Designed: 09/25/14 <b>TIER 3 PHASE 1</b> M.P.202.30 TO M.P.194.80 HSR SCOPE CHANGE Rec'd: W04 14052 IS: /NST/MJF		Designed: 3/09/12 TIER 3 PHASE 1 M.P.202.30 TO M.P.194.80 UPGRADE XINGS TO 4 QUAD WITH EGMS, VARIOUS CP'S Rec'd: W04 14052 IS: /NST/MJF		<b>MODIFICATION LEVEL</b> O.A. LAST LEVEL CHECKED DU LAST LEVEL MOD THIS TYPICAL DU LAST LEVEL BY DESIGNER DU CHANGED FROM TYPICAL? Y		CIRCUIT MODIFICATIONS ARE NOT TO BE MADE WITHOUT AUTHORITY FROM THE OFFICE OF SIGNAL DESIGN		Date: 03/09/12 Des: NST Chk: MWK AFE: 14052		<b>UNION PACIFIC RAILROAD</b> AUBURN, ILLINOIS WASHINGTON STREET SPRINGFIELD SUBDIVISION Office of AVP Engineering - Signal Omaha, Nebraska		Sh.: 1 DOT 294343T MP: 200.44 ID: CSL20044.IX	
--	--	---	--	---	--	---	--	--	--	---	--	--	--

Designed: 09/25/14 <b>TIER 3 PHASE 1</b> <b>M.P. 202.30 TO</b> <b>M.P. 194.80</b> <b>HSR SCOPE CHANGE</b> Rec*: WO: 14052 IS: /NST/MJF	Designed: 3/09/12 TIER 3 PHASE 1 M.P. 202.30 TO M.P. 194.80 UPGRADE XINGS TO 4 QUAD WITH EGMS, VARIOUS CPIS Rec*: WO: 14052 IS: /NST/MJF	CIRCUIT MODIFICATIONS ARE NOT TO BE MADE WITHOUT AUTHORITY FROM THE OFFICE OF SIGNAL DESIGN	Date: 03/09/12 Des: NST Chk: MWK AFE: 14052	<b>UNION PACIFIC RAILROAD</b> AUB

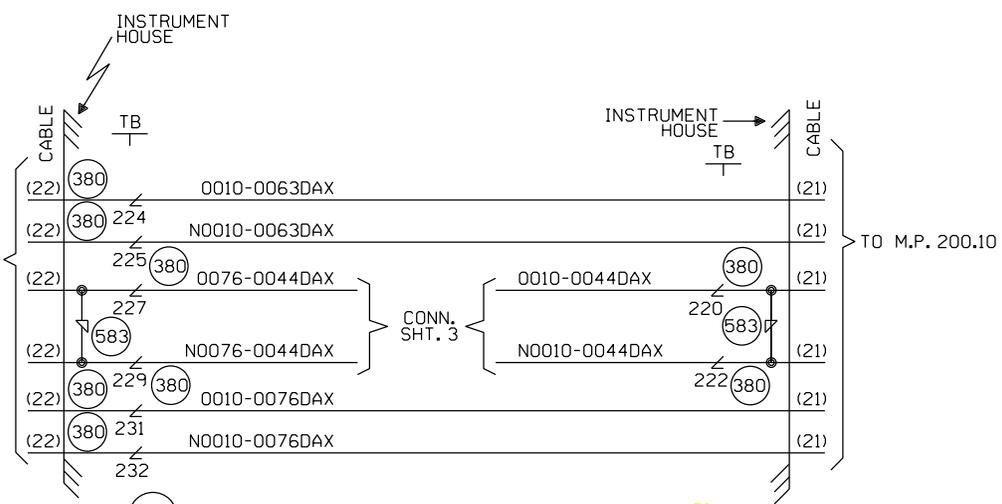
1. CABIN LOCATION NEEDS TO BE VERIFIED BY ICC PERSONNEL.
2. WHEN PLACING THE HOUSE THE 10' OR LONG SIDE OF THE HOUSE NEEDS TO BE PARALLEL WITH THE TRACKS.
3. ADD EXTENSION ARMS TO THE FLASHERS ALLOWING CLEARANCE FOR THE GATE ARM WHEN IN THE VERTICAL POSITION.
